May 11, 2023
File No. 03.0035109.00

Re: Natural Resource Protection Act Permit Application Update (L-15887)
Maine Maritime Academy Waterfront Campus Improvements
1 Pleasant Street
Castine, Maine

Graphic 1: Modifications of Proposed Structures (Yellow-highlighted with red outline represents the previous layout as shown in the NRPA Application)

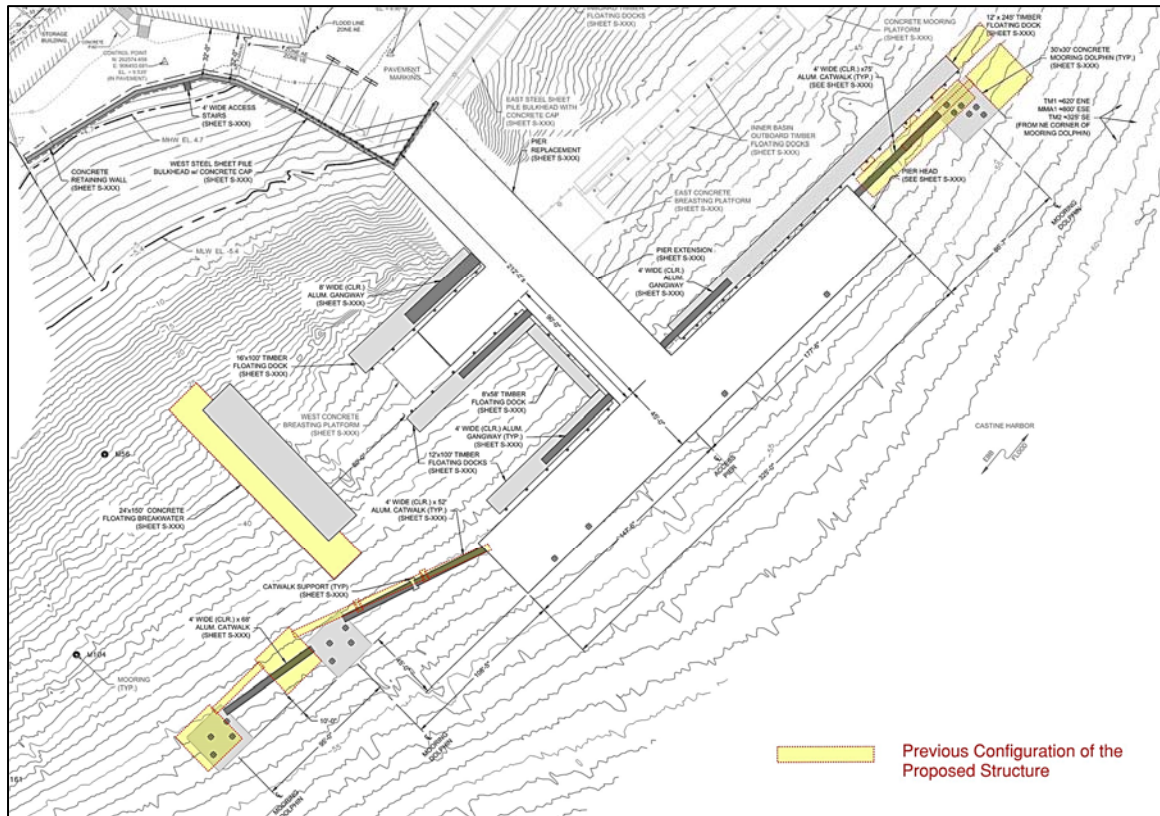
On February 24, 2023, a Natural Resources Protection Act (NRPA) application was submitted on behalf of Maine Maritime Academy (MMA) for proposed waterfront campus improvements at MMA located in Castine, Maine. After submission of MMA's NRPA permit application, discussions between MMA, the adjacent landowner, and the Town of Castine led to modifications to the size and siting of the proposed floating breakwater (FBW) as well as modifications to the layout of the proposed dolphins and adjustment of floating docks and access to the proposed dolphins. These modifications are reflected in the attached plan, **Figure 6 Rev 1**. The modifications include the following and are highlighted in **Graphic 1**:

- Reducing the FBW length to 115 feet. This represents a 23% reduction in the FBW length.
- Siting the FBW 14 feet closer to the proposed west floating docks.
- Relocating the two west proposed mooring dolphins toward the east as much as permissible while providing a heavy weather mooring arrangement for the National Security Multi-Mission Vessel (NSMV).
- Relocating the east mooring dolphin toward the west as much as permissible while providing a heavy weather mooring arrangement for the NSMV.
- Replacing the floating dock and gangways between the east end of the proposed pier T-head and the east proposed mooring dolphin with an elevated catwalk.
- Reducing the length of the east proposed floating dock.
